Review of PREPA Technical Requirements for Interconnecting Wind and Solar Generation

Technical Report
NREL/TP-5D00-57089
November 2013

The Puerto Rico Electric Power Authority (PREPA) has established minimum technical requirements (MTR) for interconnection of wind turbine generation and photovoltaic (PV) power plants (see Appendices A and B). During a stakeholder workshop conducted by the U.S. Department of Energy (DOE), the National Renewable Energy Laboratory (NREL), and the Government of Puerto Rico in May 2012, barriers to renewable energy deployment were discussed. The stakeholders, including PREPA, the Puerto Rico Energy Affairs Administration, and representatives from the Governor's Office, requested DOE and NREL assistance in a technical review of the MTRs for variable renewable energy generation.

Figure 1. Comparison of LVRT and HVRT requirements

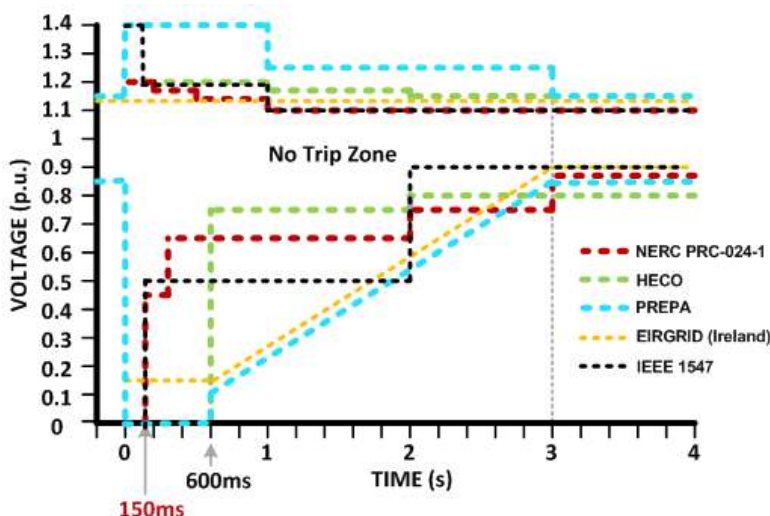
In the original MTR document, PREPA's low-voltage ride-through (LVRT) requirements for both wind and PV are similar. Wind and PV plants are supposed to remain online and ride-through zero-voltage faults for up to 600 milliseconds (ms); this is essentially a zero-voltage ride-through (ZVRT) requirement. The no-trip zone is bounded by linear voltage recovery for up to 3 seconds. PREPA sets high-voltage ride-through (HVRT) requirements for maximum high voltage at 140% of nominal for up to 1 second. A comparison between LVRT and HVRT requirements for PREPA, North American Electric Reliability Corporation (NERC), and other islands systems such as the Hawaiian Electric Company (HECO) and EirGrid are shown in Figure 1.

The draft NERC Protection and Control (PRC) Standard PRC-024-1 requires 150 ms ZVRT. Such ZVRT is a typical requirement for transmission-connected wind power plants (WPP) in the United States. The Federal Energy Regulatory Commission Order 661A also requires 150 ms ZVRT, but recovery time is determined on a site-by-site basis depending on the local grid characteristics and protection schemes. Longer ZVRT requirements are necessary for WPPs connected to weaker lines (typical for smaller island grids). A 600 ms ZVRT requirement is implemented in the HECO system. EirGrid also requires 600 ms ride-through but at 15% voltage and with longer recovery time. Such longer zero-voltage requirements and slower rate of recovery suggested by PREPA is justified for weaker island systems to avoid tripping of the wind generators.

Currently, most U.S. utilities have adopted the Institute of Electrical and Electronics Engineers (IEEE) Standard 1547 for interconnecting distributed resources on the distribution system. IEEE 1547 covers interconnection of all types of distributed energy resources (DER) up to 10 mega volt ampere (MVA) at the point of common coupling. IEEE 1547 clearing times are also shown in Figure 1.

Figure 2. E-ON reactive current droop

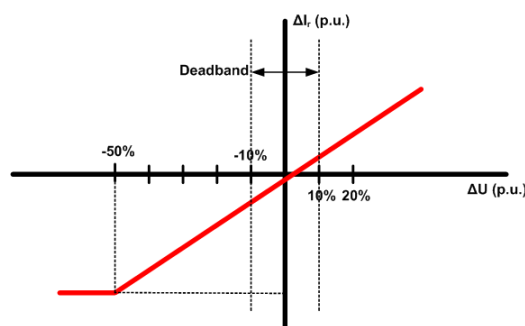
Although it is not necessary for the converter to produce fault current during the fault in the United States, fault voltage support is required by European grid codes. The turbine converter injects reactive current into the fault as a function of percentage of voltage drop. For example, German utility operator E-ON requires reactive current injection according to the droop line shown in Figure 2 (a minimum of 2% positive sequence reactive current for every percent of voltage drop below 100%). This implies that for faults with voltage drops of 50% or lower, the reactive component of current goes to 100% or higher (depending on the current rating of the converter—usually 1.1-1.2 p.u.).

We recommend PREPA further examine the reactive current injection requirement and consider implementation of a similar droop. Currently, PREPA requires that “during the fault conditions, the wind generation facility shall operate on maximum reactive current injection mode.”

PREPA’s Response to Recommendation #1:

In accordance with NREL’s recommendation to further examine the reactive current injection requirement and consider implementation of a similar droop, PREPA revised the MTRs to include the following in the section 1.a.iv:

Figure 3. Envelope of international LVRT/ZVRT/HVRT requirements

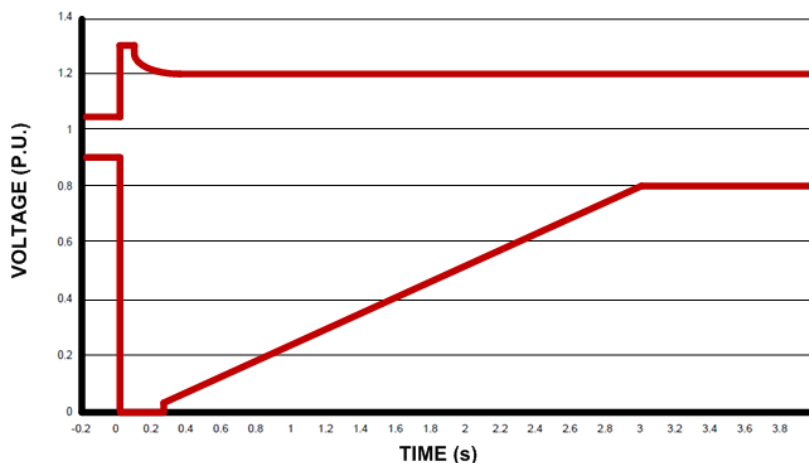
Situations with over-voltages may arise due to sudden load loss, unbalanced faults, and other conditions. The resulting over-voltages may have different magnitudes and durations depending on the scenario. PREPA HVRT requirements (as shown in Figure 1) are the highest compared to various grid codes that can be found in literature [1]. The highest HVRT requirements in some power systems are limited at 130% of rated voltage. In other island systems (such as HECO or EirGrid) the HVRT is limited at 115% to 120%. There are some grids that require 130% HVRT. Boundaries of fault ride-through (FRT) requirements from several European utilities listed in [1] are shown in Figure 3 for reference purposes.

PREPA’s Response to Recommendation #2:

Based on NREL’s recommendation to review the HRVT requirements, PREPA revised the MTRs by reducing the 140% overvoltage ride-through (OVRT) time to 150 ms, and also included a new OVRT range of 130%-125%. The modified section 1.b.i incorporates this new requirement into the following table:

Figure 4. Example of PV plant interconnection with STATCOM on PV collector bus

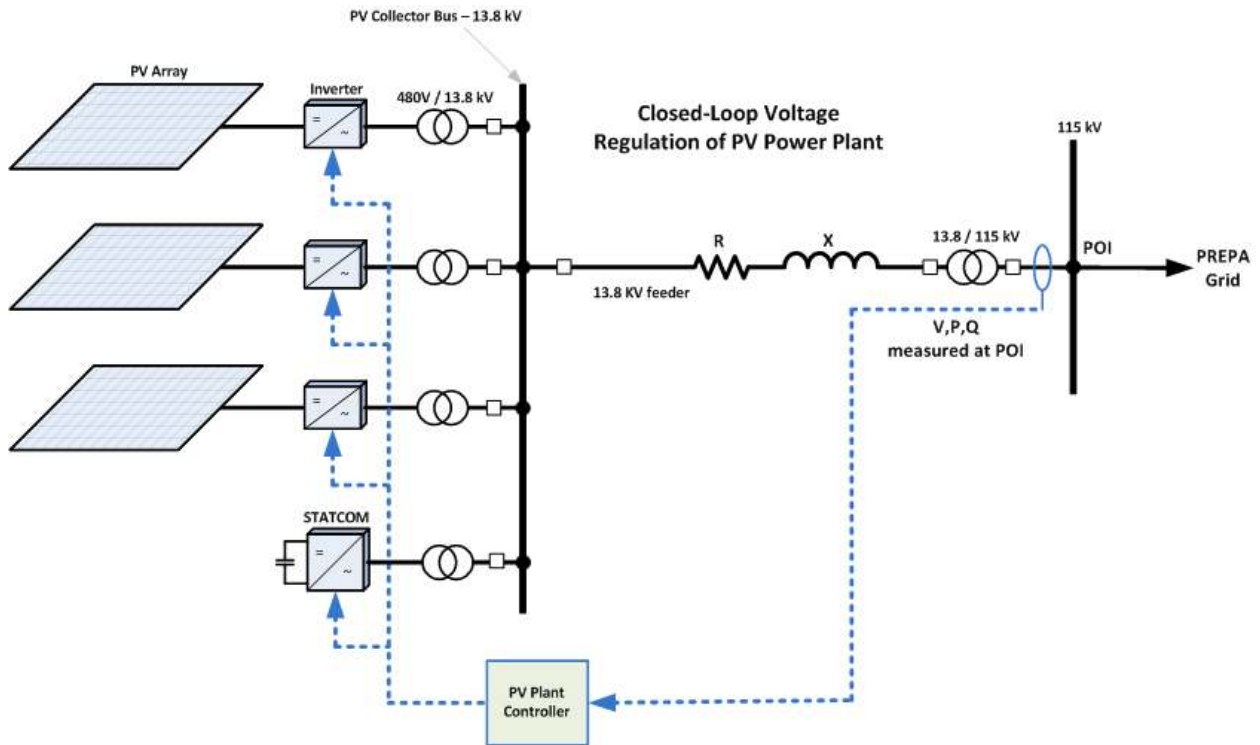
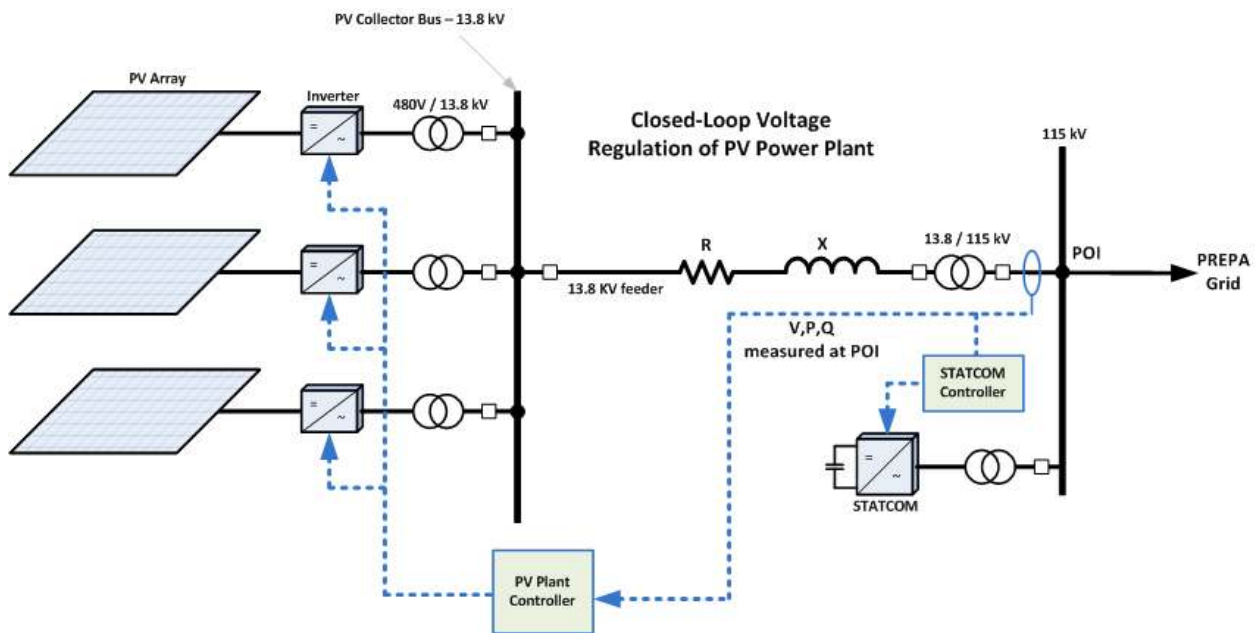
Some examples of closed-loop voltage regulation for PV power plants are shown in Figure 4 and Figure 5 where PV inverters are connected to a 13.8 kilovolt (kV) collector bus, and then to PREPA's 115 kV transmission system via medium voltage (MV) feeder and step-up transformer. The closed loop voltage regulation is performed by a PV plant controller that senses remotely the voltage at the POI. This control loop allows for the best mitigation of voltage fluctuations since it allows eliminating voltage impacts in one location. In the case of other existing feeder voltage regulation (switched capacitors, tap-changing transformers, etc.), there may be some difficulties coordinating PV inverter controls with existing feeder voltage regulation. Care must be taken for PV not to carry an excess share of reactive demand of other feeder loads, avoiding interactions between controls and addressing hunting regulator stability issues.

In cases where voltage control capability of PV inverters is absent (IEEE 1547 compliance) or limited, additional devices such as STATCOM or Static VAR Compensator (SVC) can be implemented on both PV plant collector (Figure 4) or transmission bus (Figure 5) levels. We think that switched capacitor banks or tap changer transformers (in case they already exist in that particular feeder) can be accepted, and in some cases can eliminate a need for additional STATCOM devices. Different regulation strategies can be implemented with these schemes. For example, fast voltage fluctuations can be mitigated with PV inverters, and slower ones can be addressed by the existing feeder equipment. Appropriate time constants must be chosen to coordinate these various controls.

PREPA's Response to Recommendation #5:

PREPA's MTR's are specific to transmission (115 kV) and sub-transmission (38 kV) level systems. In PREPA's actual applications, the feeders used by the PV and wind facilities are internal; excess share of reactive demand of other feeder loads is not expected. NREL's comments regarding this issue seem to be more applicable to distribution system feeders. The MTR's actual reactive power requirements provide flexibility for different types of technologies at the renewable energy facility. These technologies include combinations of different equipment like inverters, STATCOMs, SVCs and capacitor banks. As a result, no changes were made to the MTRs.

Figure 6. Types of reactive power capability curves for wind generators

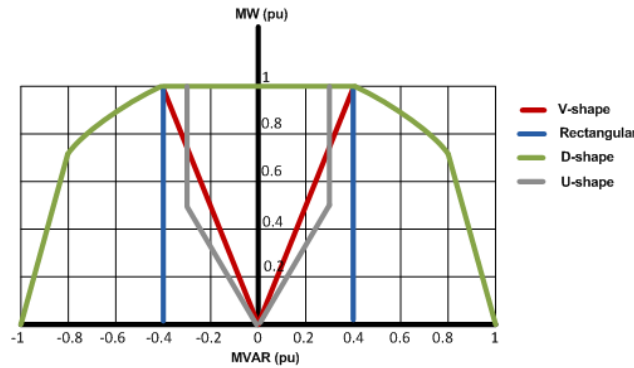
Both double-fed induction generators (DFIG) and full-converter WTGs may come with a variety of V-shape, rectangular, D-shape, or U-shape reactive power characteristics as shown in Figure 6. In some cases, reactive power characteristics can be non-symmetric. One advantage of WTGs with rectangular and D-shape reactive capabilities is the possibility of providing voltage regulation service during no-wind periods. The same is true for PV inverters because they can provide voltage regulation at night by operation in a STATCOM mode.

In its minimum interconnection requirements PREPA specifies a rectangular reactive power capability curve for both dynamic and total ranges. A comparison of reactive power capabilities between HECO, PREPA, and EirGrid is shown in Figure 7. Similar rectangular reactive power curves are required by HECO in their model PPA document [2]. EirGrid implemented a U-shaped reactive capability curve that uses a reduced power factor range [or a permissive mega volt ampere reactive (MVAR) range] below 50% or rated power.

PREPA’s Response to Recommendation #7:

Figure 7. Comparison of reactive power curves

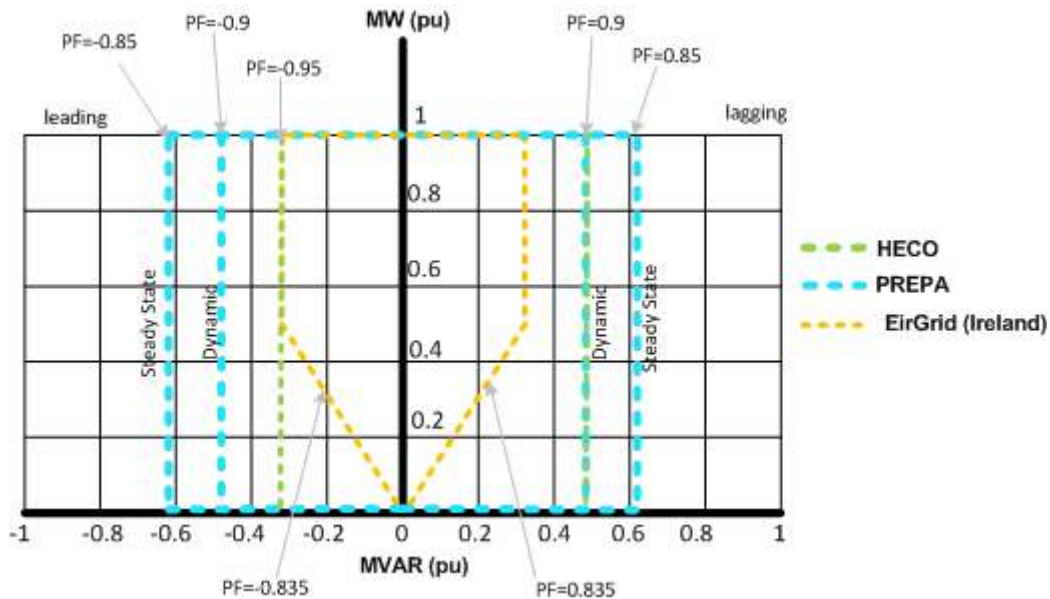
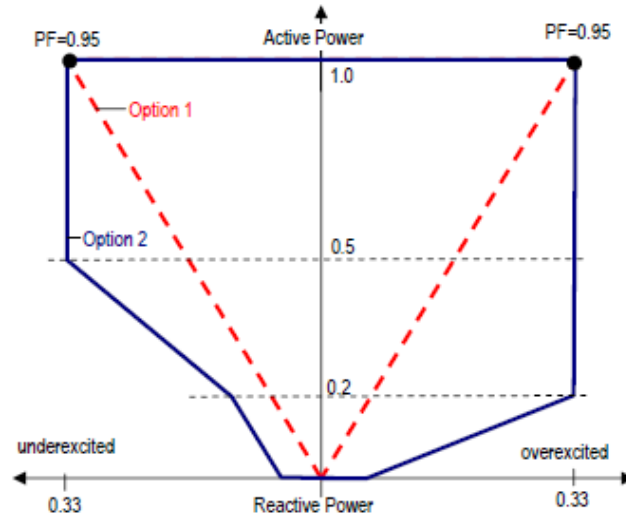
We agree with PREPA that rectangular reactive capability is more beneficial. However, a requirement to maintain reactive power range at full output by PV inverters represents a change with respect to historical industry practice and has some cost impact associated with it. This cost impact could be substantial if the PV plant relies on inverters to provide all required reactive power since additional inverter capacity will be needed. For example, PV inverters would need 11.1% of additional capacity to meet PREPA’s dynamic reactive power capability and 17.6% of additional capacity to meet the steady-state reactive power capability. Otherwise, the plant has to be de-rated or external reactive power support needs to be installed.

For some DFIG wind turbine topologies the reactive power capability curves are not symmetrical, as shown in Figure 8 (option 2). This is why permissive MVAR ranges as shown in Figure 7 for EirGrid make sense for systems with DFIG-dominated wind power.

PREPA's Response to Recommendation #8:

Figure 9. LVRT sensitivity to SCR [4]

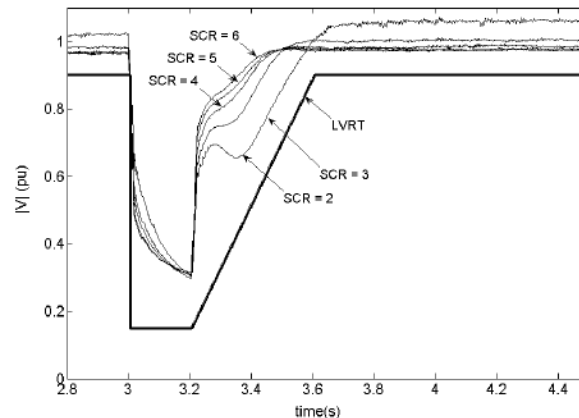
PREPA limits SCR=5 as the minimum permissible level for interconnecting both wind and PV projects. We think this level is adequate. However, we'd like to point out that in some cases even lower SCR might be reasonable assuming LVRT requirements set by PREPA as shown in Figure 1. An example of LVRT sensitivity to SCR for a DFIG wind farm is shown in Figure 9. The turbine speed of recovery degrades as SCR is decreased, but the LVRT requirement is still met even at SCR=2.

PREPA's Response to Recommendation #9:

PREPA maintained the SCR limit on 5. Studies indicate that SCR levels below 5 can cause VRS control instabilities in some applications.

Figure 11. Various frequency droop characteristics

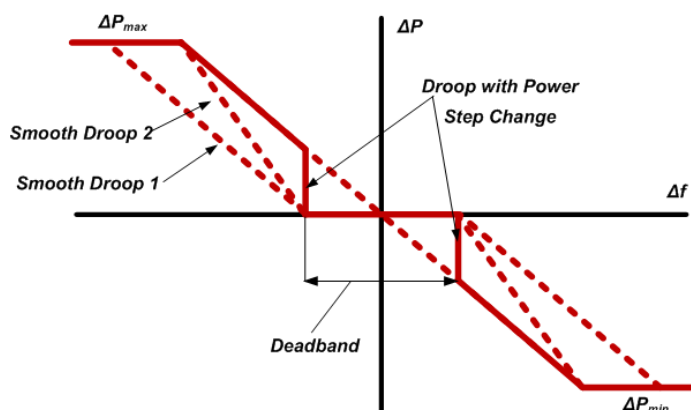
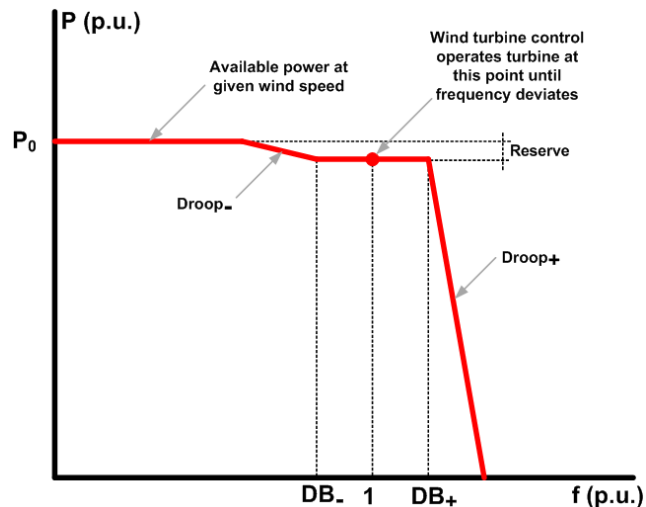
We think that more detailed specifications on the exact type of droop and dead bands would be necessary to remove any ambiguities and misinterpretations for project developers. Primary frequency response (PFR) is one of the most expensive services for renewable generation operators since power reserves must be constantly maintained for up regulation by curtailment (loss of production) or by the use of energy storage devices (extra investment cost).

We would also like to point out that both WTG and PV power plants can reduce their power outputs very effectively so non-symmetric droop characteristics similar to the one shown in Figure 12 can be implemented. Both positive and negative droops and frequency dead bands can be controlled and set by a wind or PV power plant SCADA system to provide aggregate plant PFR that meets power system needs. We recommend PREPA consider the possibility of requesting an option of setting PFR parameters (dead bands, droops, reserve margins) remotely. PFR responses by wind and PV power are additional controls that can be tuned to provide optimum performance and maximum reliability to the PREPA power system and can become a source of additional control flexibility for PREPA system operators.

PREPA's Response to Recommendation #10:

Per NREL's recommendation, PREPA added the following clarifications to Section 6:

- The frequency response dead band shall not exceed 0.02%.
- If energy storage systems are utilized to comply with the frequency regulation requirements, and during a disturbance the system frequency stays below 59.7Hz, the facility frequency response shall be maintained for at least 10 minutes.

Figure 13. Inertial response by type 3 WTG at lower wind speed (NREL model)

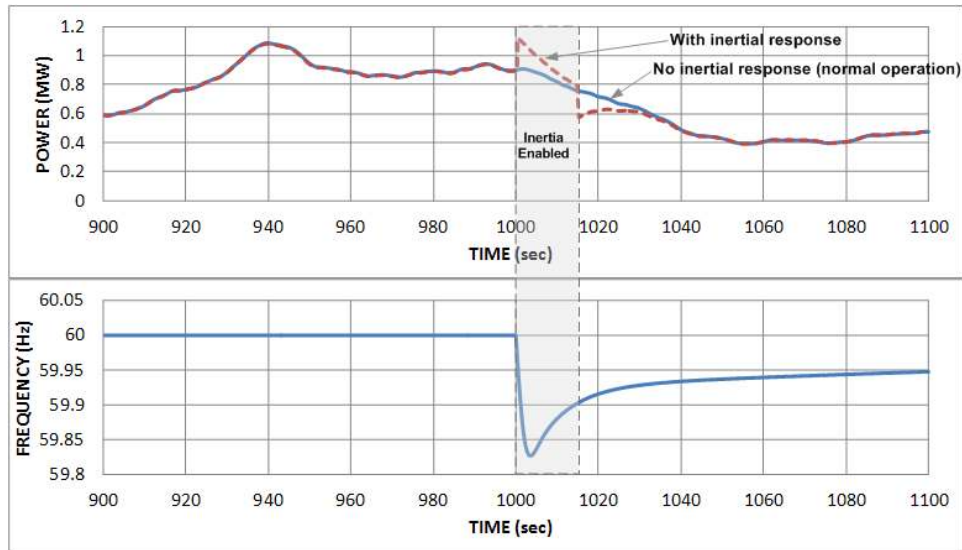
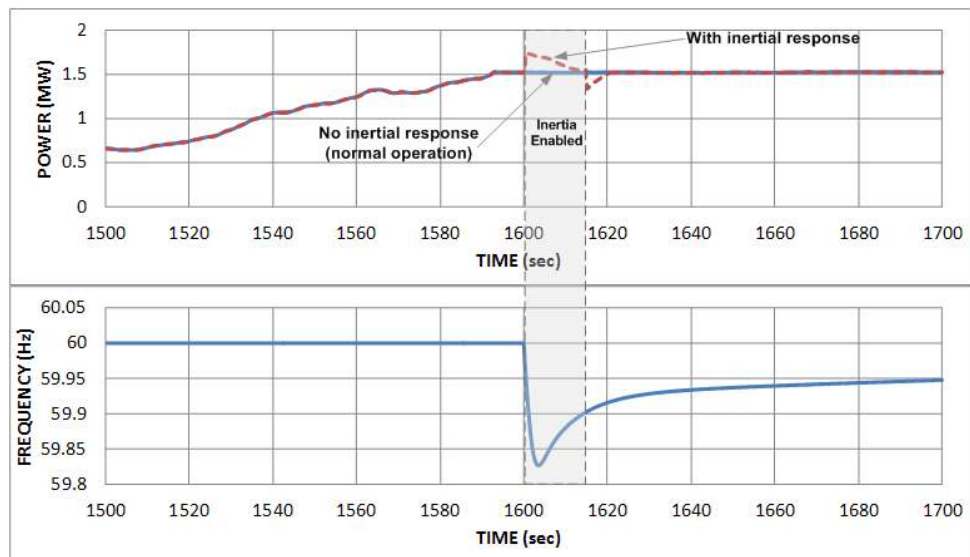
Further, PREPA requires WTG controls to provide inertial response. This requirement also needs more detailed explanation. The main questions here are:

1. What is the priority of inertial response over 10% real-power increase during large frequency declines (more than 0.3 Hz)?
2. What are the dead bands for inertial response for smaller frequency declines?
3. Transition from inertial response to PFR must be specified.

Inertial response by wind power is highly dependent on initial pre-fault conditions of each individual wind turbine (revolutions per minute and wind speed). The aggregate inertial response of the whole WPP will be different than individual WTGs.

Inertial response by wind power is “energy neutral.” Initial periods of overproduction triggered by utilizing rotor inertia are followed by a period of underproduction (someone else needs to meet the load during this period) as shown in Figure 13 and Figure 14. Nevertheless, the overall benefit of such inertial response is significant because it helps the power system in the form of arresting initial rate of change of frequency and “gaining time” for a slower PFR of conventional generation.

The recovery period and return to normal operations after providing inertial response can be different depending on the available wind resource. At rated wind speed (Figure 14) the return to pre-disturbance level is much faster than at lower wind speed (Figure 13) because of more favorable conditions (there is power available from wind to provide incremental electric power).

PREPA's Response to Recommendation #12:

Figure 15. Wind power participation in AGC (NREL model)

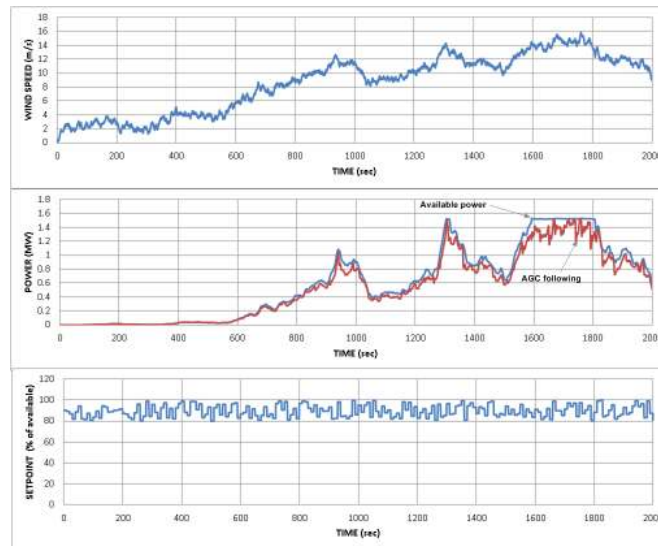
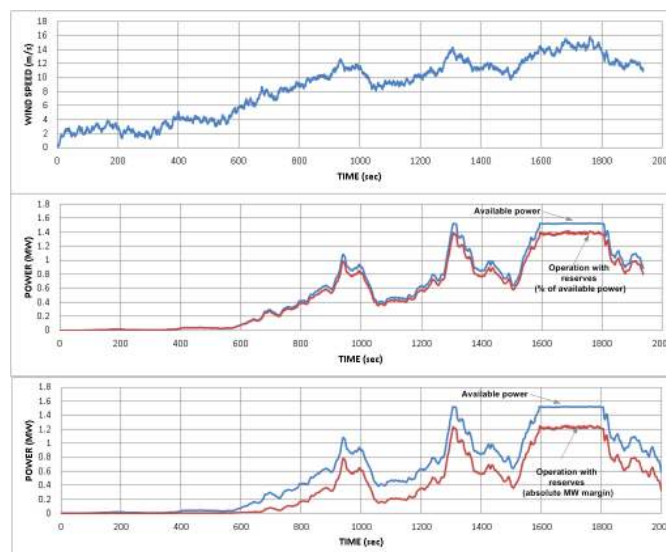
One important question that might affect the MTRs is if PREPA envisions wind and PV participation in automatic generation control (AGC) at some point in the future. If so, then such capability must be requested in the requirements. An example of wind power participation in AGC is shown in Figure 15, where a wind turbine is able to follow AGC signals by having available reserve margins for up regulation.

There are other active power control schemes for wind power rather than inertial/PFR and RR limiting. If required, wind power can operate with spinning reserves as shown in Figure 16. It can provide continuous reserves as a percentage of available power or absolute reserves in megawatts.

Such advanced active power control schemes might be beneficial to PREPA under certain circumstances. During periods of high wind production at light loads, fossil fuel units may need to be forced offline due to the excessive wind power, which leads to another problem of inadequate unit dispatch capability in system operations. The excessive wind power could serve as a dispatchable reserve rather than just curtailing for security concerns. In addition, such capability could release the regulation of diesel and other combustion generation when a high concentration of wind power is installed in an isolated island grid.

PREPA's Response to Recommendation #14:

PREPA asked for the minimum known necessary technical requirements that were important for optimizing the power system performance under high levels of renewables penetration, while providing the necessary mitigation to the impact of these resources on the electric system. Recognizing the level of complexity that the implementation of such advanced active power control schemes might have on the projects, PREPA has decided not to require renewables to provide or participate in AGC at this point in time. However, PREPA understands the benefits of these services by renewables, and may require them in the future if necessary.
